LIDCO, Pars SEE Zone, Assaluyeh,
Integrated Methanol and Ammonia
Plant 3000 MTPD MeOH / 900 MTPD NH3 PROJECT

General Arrangement Drawing (incl foundation load details)

Document No. 17735-04

**Airpack B.V. - Air Compressor –
Integrated Methanol and Ammonia Plant
17735-COM General Arrangement Drawing (incl foundation load
details) (K020)**

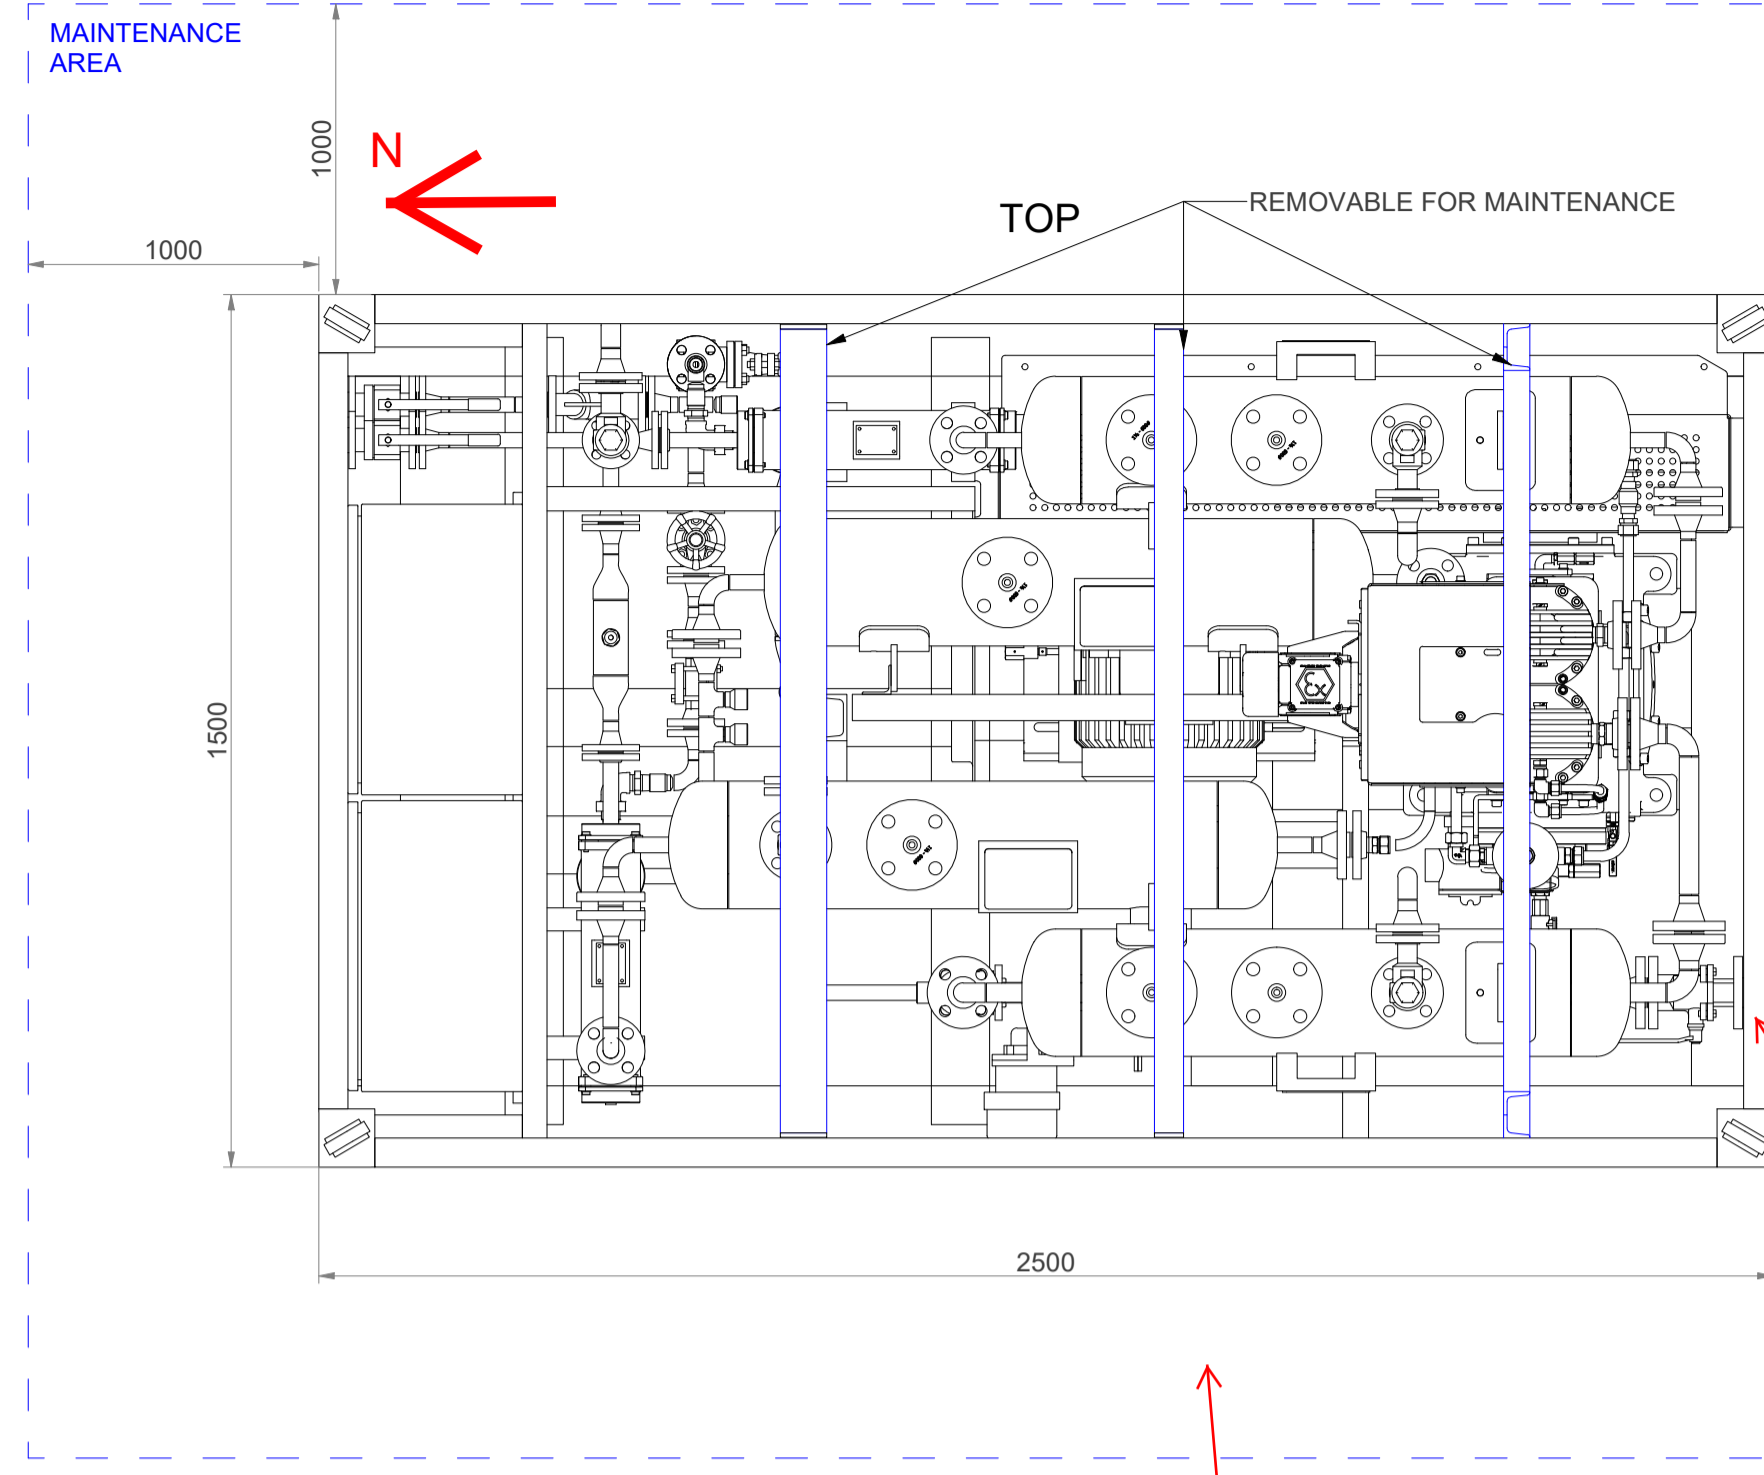
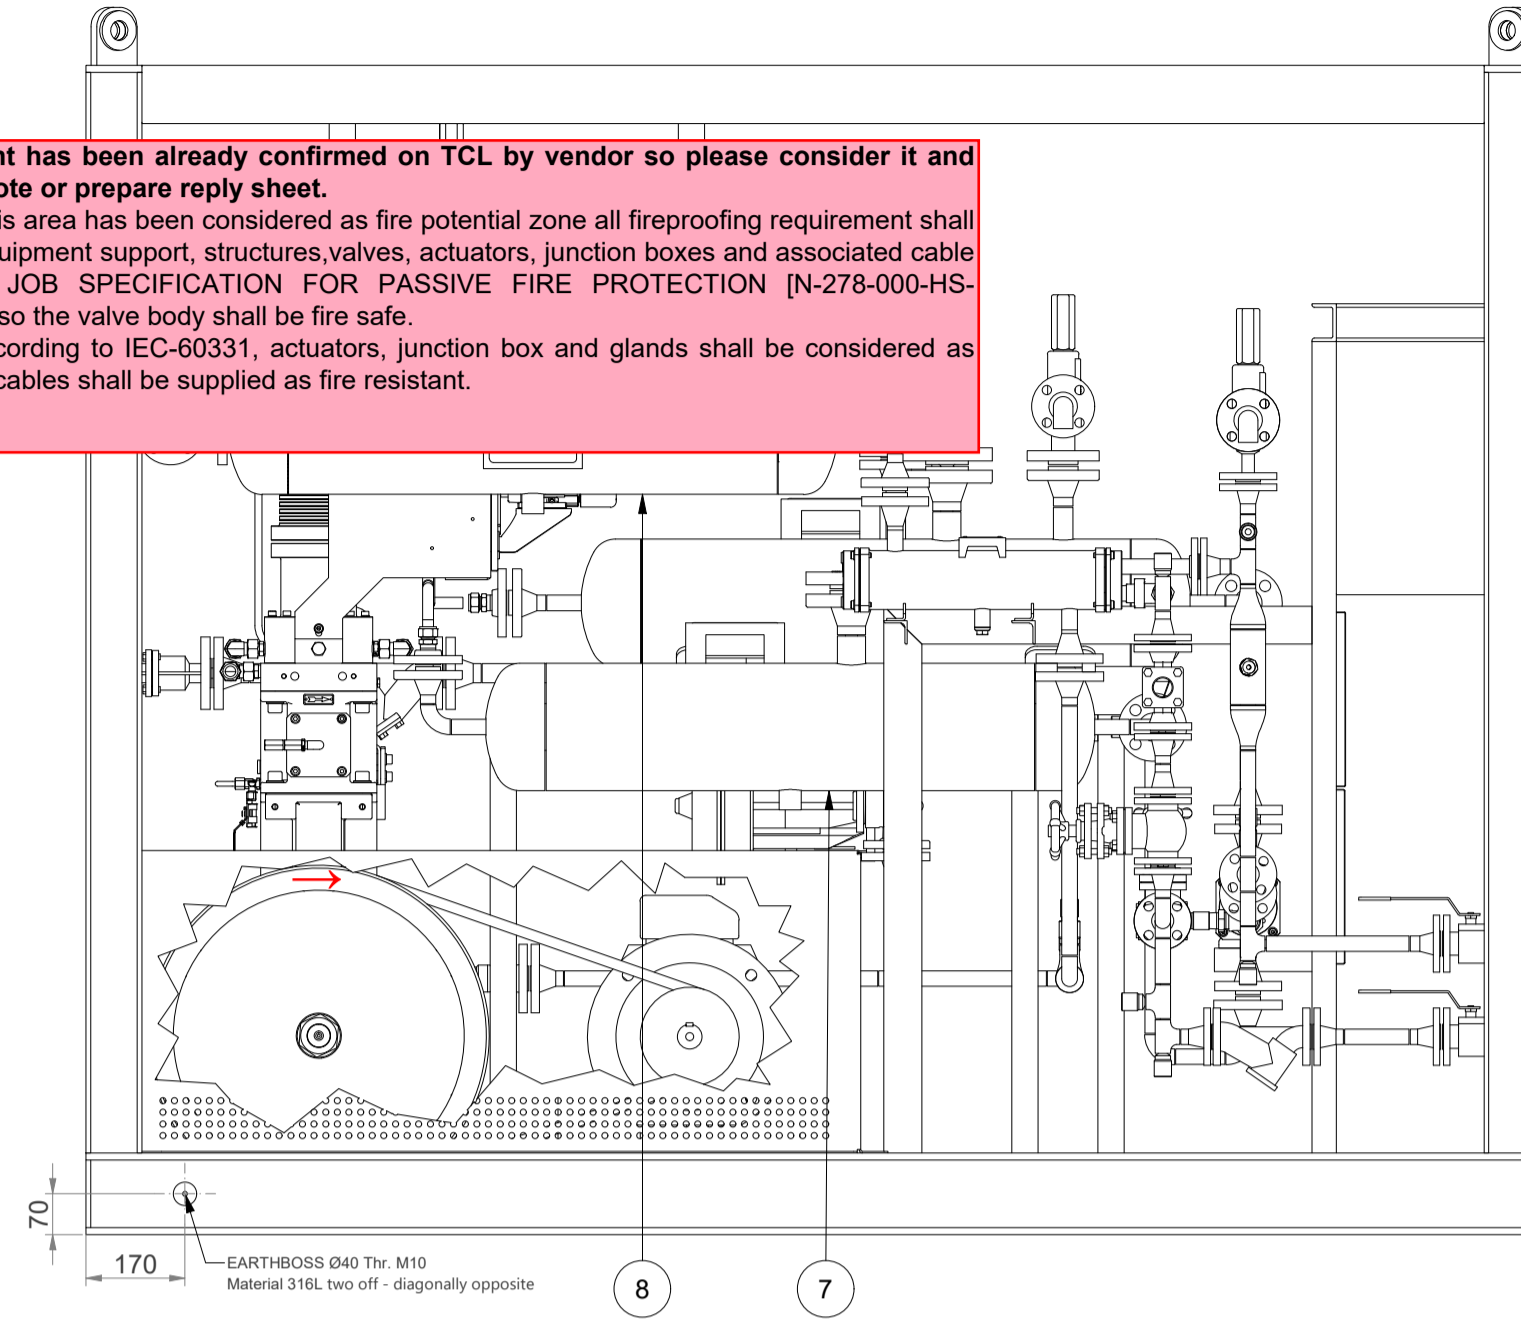
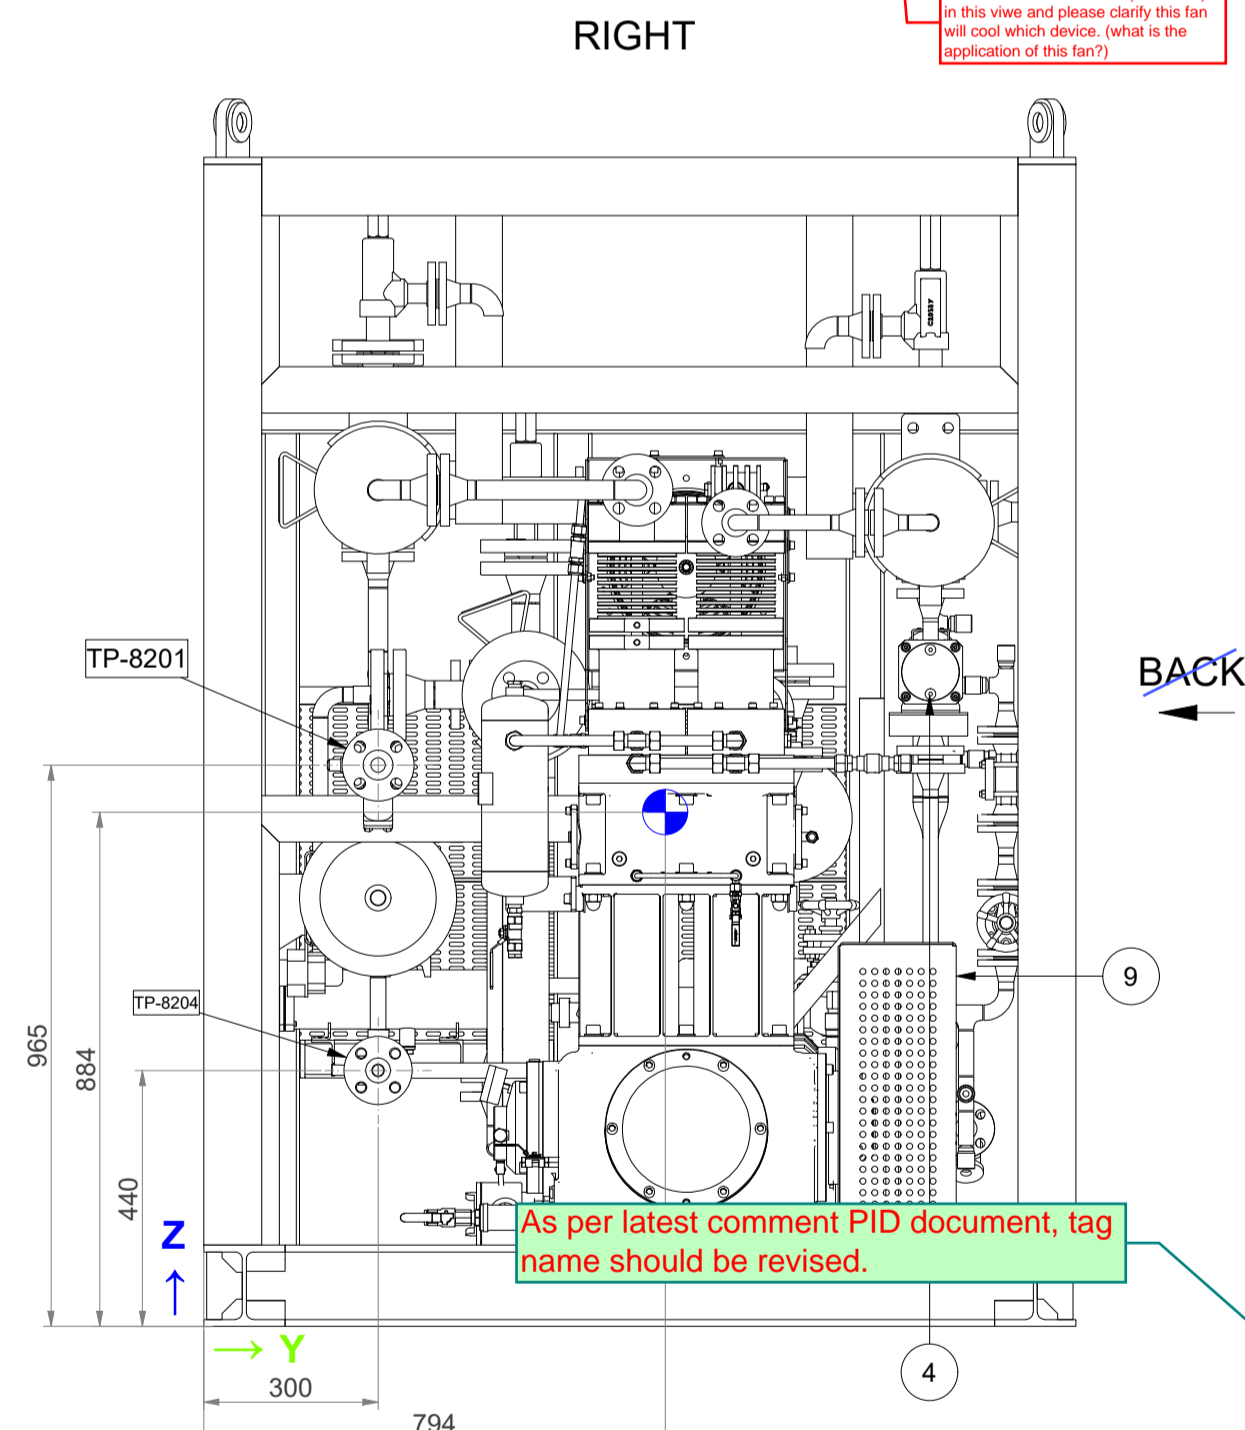
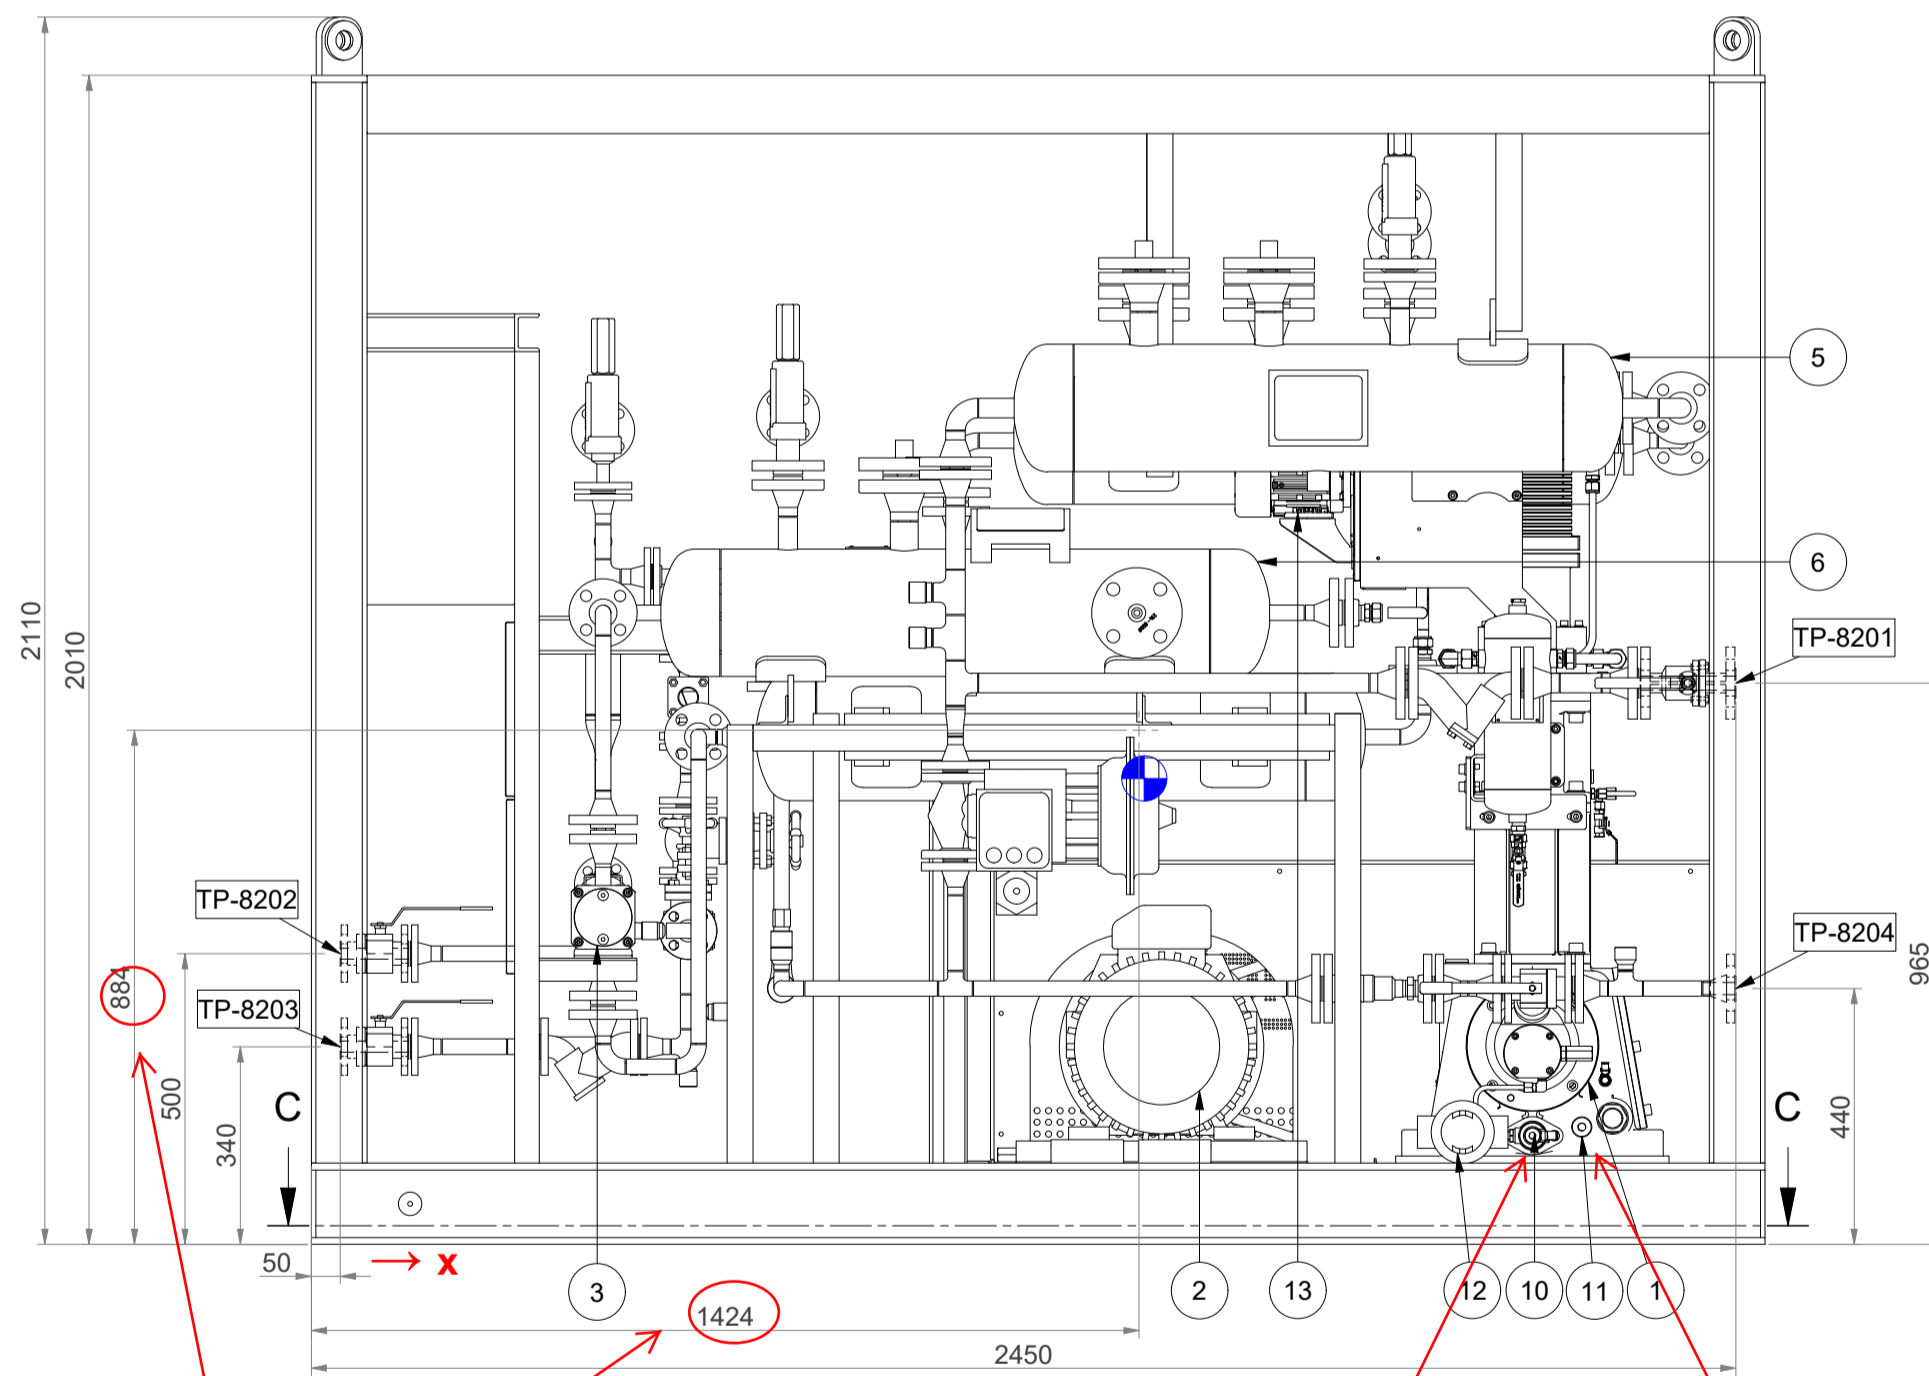
The below comment has been already confirmed on TCL by vendor so please consider it and implement it as a note or prepare reply sheet.
 - With considering this area has been considered as fire potential zone all fireproofing requirement shall be considered for equipment support, structures, valves, actuators, junction boxes and associated cable trays according to JOB SPECIFICATION FOR PASSIVE FIRE PROTECTION (N-278-000-HS-JSD-1740-00, and also the valve body shall be fire safe.
 also please note according to IEC-60331, actuators, junction box and glands shall be considered as explosion proof and cables shall be supplied as fire resistant.

foundation loading data is not complete. loading data should be completed (seismic&wind)

-Please specify Tie-in Tag No. and Nozzle dimension at this view.
 -Pipe support of lines at the edge of package where located in vendor area is by vendor

Instrument Comment:
 - Instrument Nozzle details table, Cable Tray to be indicated on this document, otherwise, this document cannot be reviewed by instrument Dept.

Please also mark item 13 (fan motor) in this view and please clarify the fan will cool which device (refer to the application of this fan?)

It seems instruments are not displayed in GAD

Please add a section for reference documents and please refer to compressor datasheet, P&ID and other major docs

According to vendor reply on VPIS, Sketch of lifting/transport arrangement will be provided as additional page on GA.

What do these dimensions refer to? (Are they related to COG?)

Please clarify if this oil pump has any PSV (positive displacement pumps require PSV for protection)

Please display oil drain of sump on GAD

Please mention/mark the port for filling the oil sump

Please also add weight of compressor, dampers, and coolers as well.

to be clarified there is V-belt

Please mention "maximum maintenance weight"

Please correct the name (there is no nitrogen)

As per latest comment PID document, tag name should be revised.
